# UNITED STATES PATENT AND TRADEMARK OFFICE

APPLICATION NO.	FILING DATE	FIRST NAMED INVENTOR	ATTORNEY DOCKET NO.	CONFIRMATION NO.
10/603,023	06/24/2003	Marc Weydert	DN2002105	2594

<b>Office Action Summary</b>	<b>Application No.</b> 10/603,023	<b>Applicant(s)</b> WEYDERT ET AL.	
	<b>Examiner</b> WILLIAM K. CHEUNG	<b>Art Unit</b> 1796

## **DETAILED ACTION**

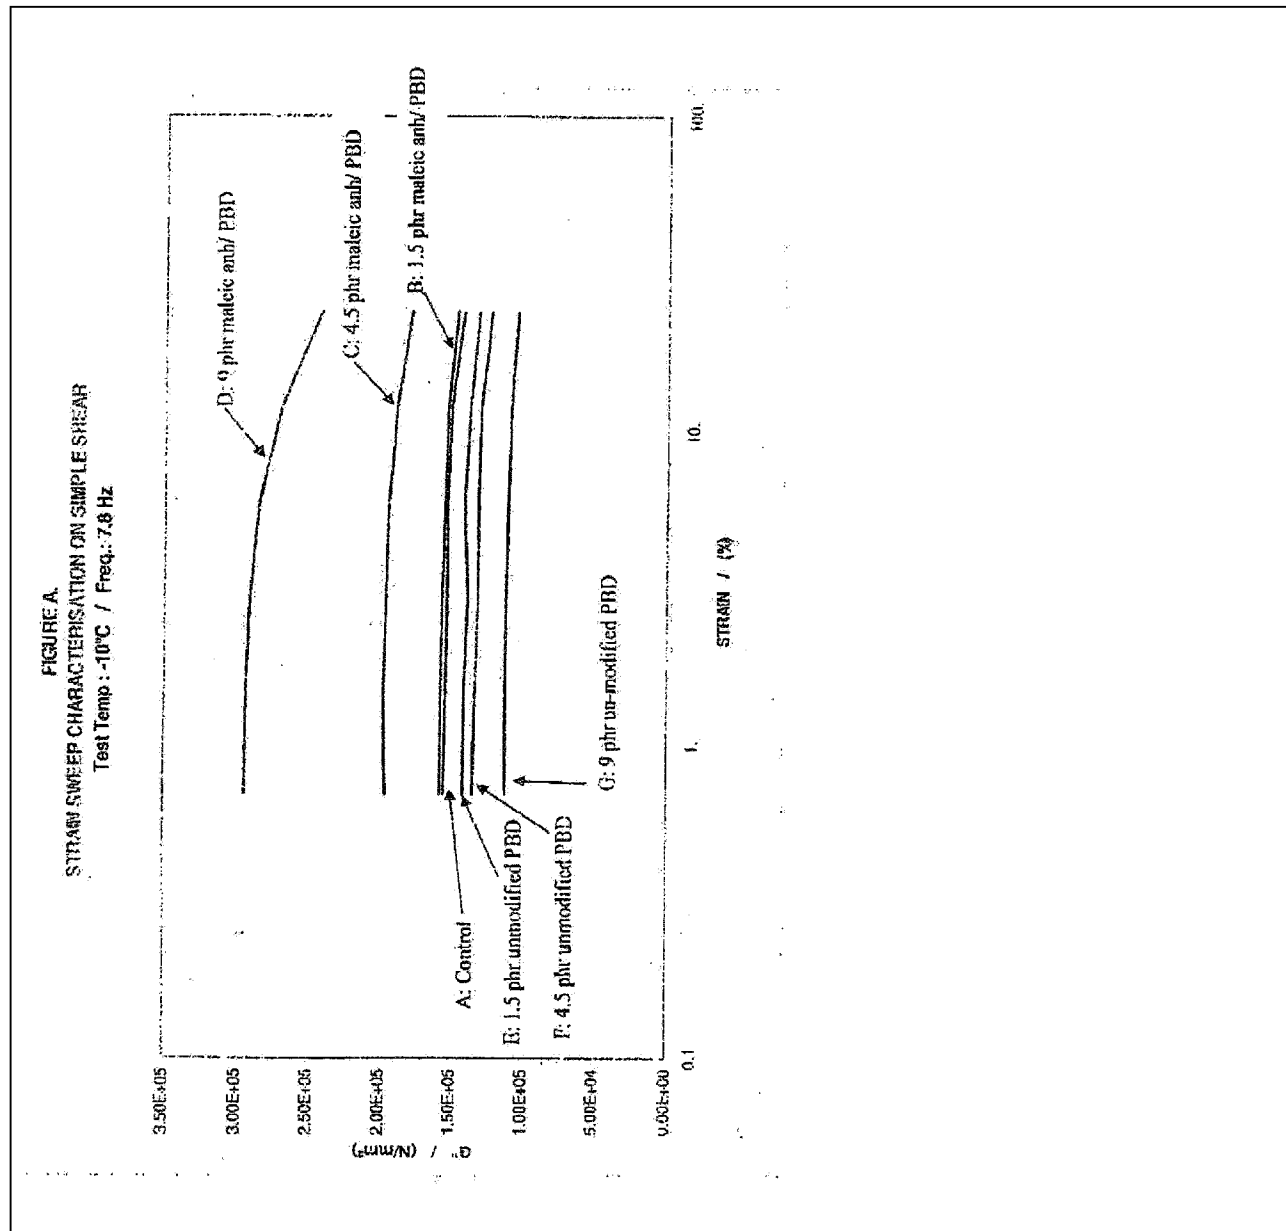
For the instant application, the declaration filed September 15, 2008 fails to establish that the "comparative data" have shown the criticality of the claimed "maleinized" feature because the argued "unexpected" results are actually "expected" in view of the teachings of Corvasce et al. and Huynh-Tran et al. Applicants argue that the maleinized polybutadiene adduct composition exhibits loss modulus properties at 10 °C that are nonlinear over the strain range while the loss modulus properties at 10 °C of un-modified polybutadiene composition is constant over the strain range. However, such argument is not persuasive because the control samples which include the un-modified polybutadiene samples also exhibit non-linearity in loss modulus properties in the entire measured strain ranges.

Regarding applicants' argument that the lower stiffness at large strain may be attributed to the softer core shell with the adduct of maleic anhydride and polybutadiene

as compared to the un-modified polybutadiene, the argument is not supported by the comparative data as submitted. Applicants must recognize that the entire loss modulus ranges of the maleinized polybutadiene samples are significantly higher as compared to the un-modified polybutadiene samples (see the following Figure).

Regarding the increase of the entire loss modulus ranges of the maleinized polybutadiene samples, applicants must recognize that maleinized polybutadiene comprises a higher maleic anhydride content and a lower butadiene (soft segment) content as compared to the samples containing un-modified polybutadiene. As expected by one of ordinary skill in art, a higher maleic anhydride content compounding with a lower polybutadiene contents cause the loss modulus of the maleinized polybutadiene containing samples to be elevated (not lowered) for the entire strain range as shown in the figure as shown above. In view of the reasons set forth above, the comparative data filed fail to show the criticality of the claimed invention. Applicants must also recognize that Huynh-Tran et al. (page 1, [0002]) clearly teach that adhesion is a significant factor in the overall performance of composite materials, which implies a significant improvement or impact on the mechanical properties such as the argued "loss modulus" properties.
